Re: McCallum Road Landfill Site
Permit #PR-3955

Re: McCallum Landfill Site
Permit No. PR-3955

re PR-3955 - McCALLUM ROAD LANDFILL SITE

AUG. 1987.
PR 3955

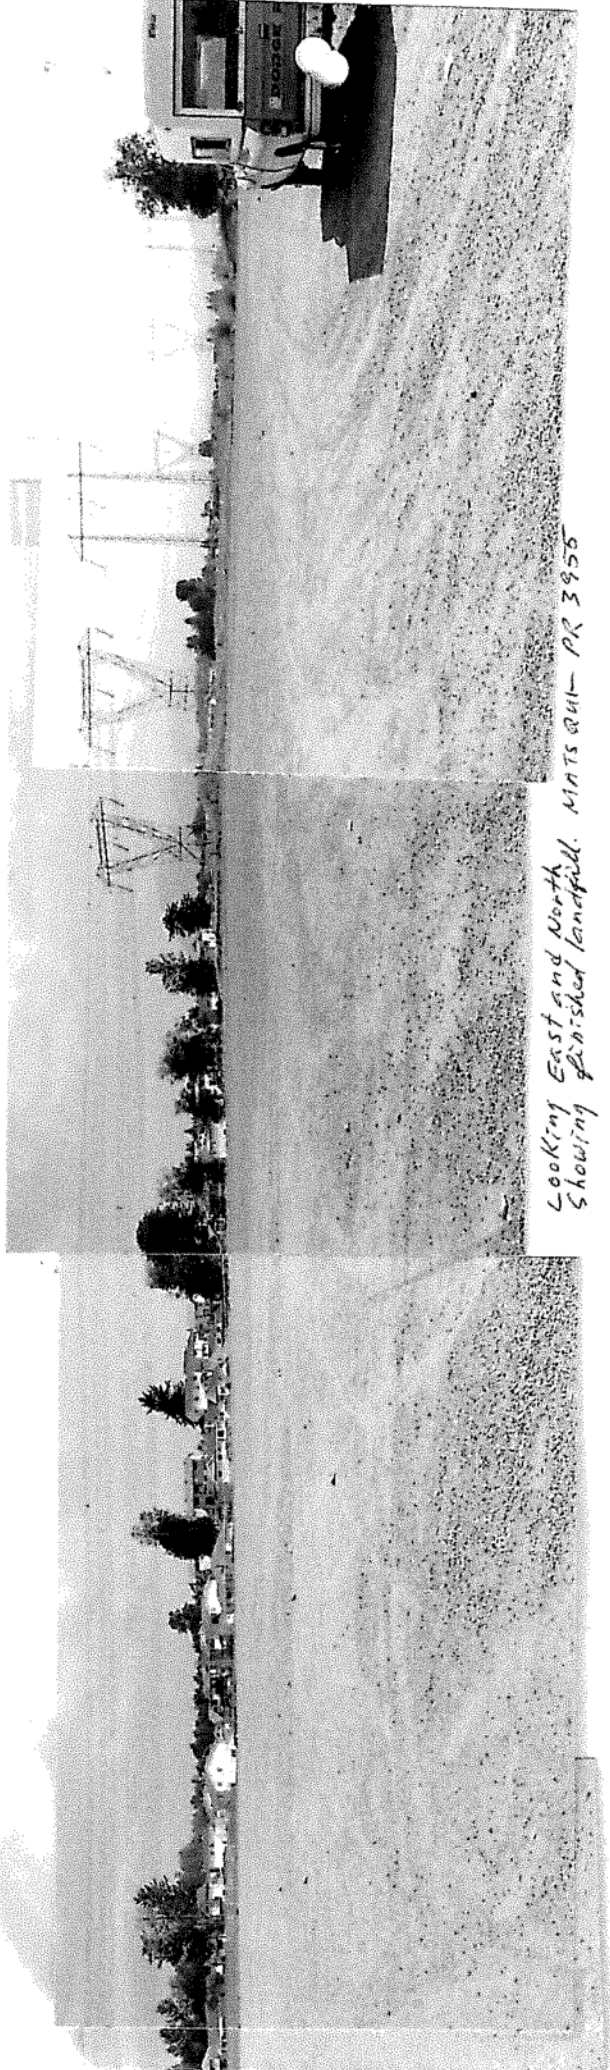
Looking East and North
Showing finished landfill. MATS OUT- PR 3955

Picture shows a sump where
dual pumps are installed to
pump leachate to the Municipal
system.
